RE: Fremont Paving and Redi Mix, Inc. McCumber Pit M2000-151 (TR-2)
Adequacy Response #1

Please see the answers to the Adequacy Review #1 questions.

**McCumber Hill Pit
Phase Map
1/16/24**

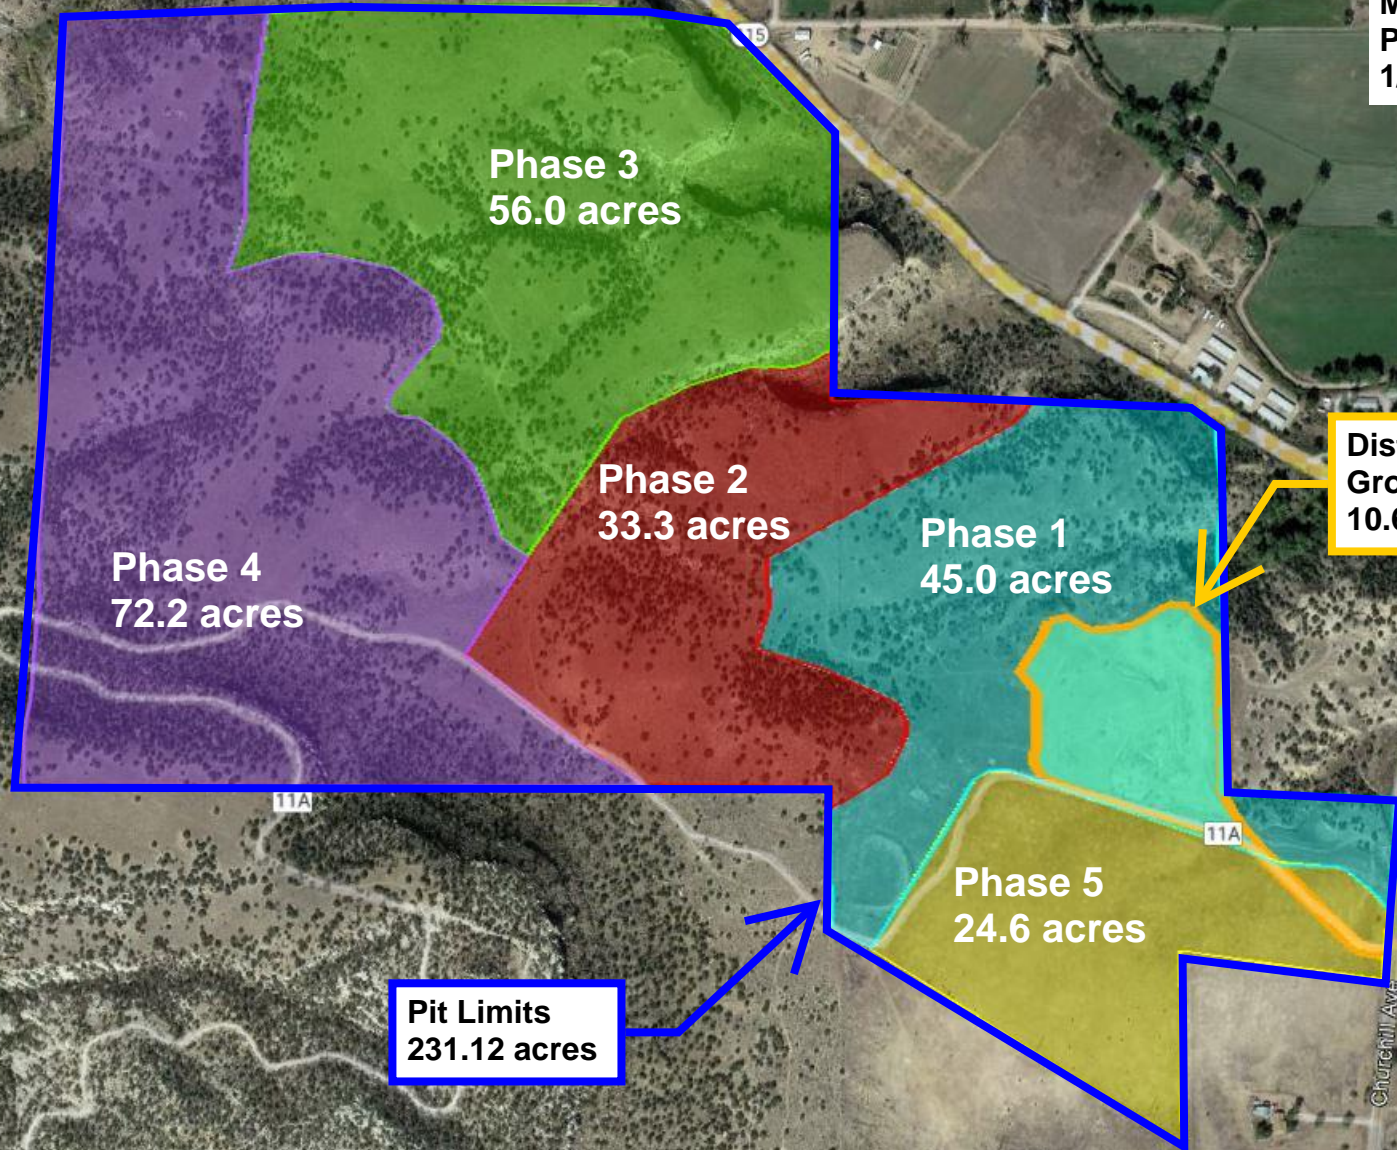
1. Fremont will use a dozer to reclaim the slopes to a 3H:1V and will use a cut and fill method. Fremont will reclaim concurrent to mining.
2. The maximum length of the highwall will be 650 feet.
3. Fremont requests the affected area boundary to be the same as the permit boundary. The previously submitted map should designate both the permit and affected area boundaries. Enclosed is a map showing Phase 1 as it currently stands. Fremont would like to keep the current phasing as designated in the attached phase map.
